NUMBER: 19-003-14

GROUP: Steering

Clunk And/Or Bump Felt Through The Steering Wheel Under Moderate Braking And/Or Driving Over Rough Roads

2011-2012	(WD)	Durango
2011-2012	(WK)	Grand Cherokee

Fig. 1 Lower Intermediate Shaft

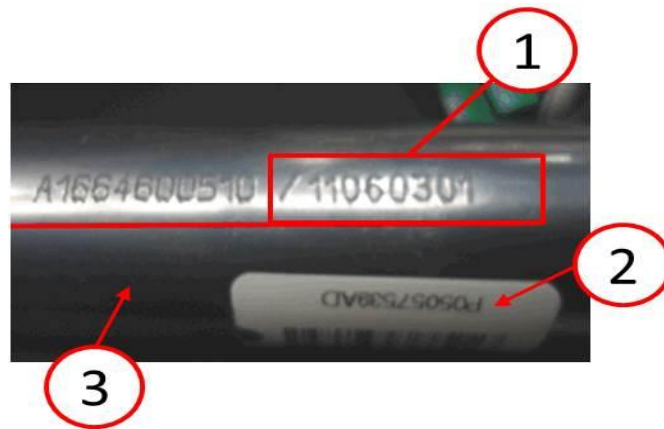
NOTE: **The new lower intermediate shaft must have a julian date greater than August 01, 2011 and is located near I-Shaft barcode label (Fig. 1). The julian date has a series of eight digits coded as follows, YY=Year MM=Month DD=Date SS=Shift. For example, the julian date in (Fig. 1) is 11060301, decoded the intermediate shaft was manufactured Year=2011, Month=June, Date=03 Shift=01.******
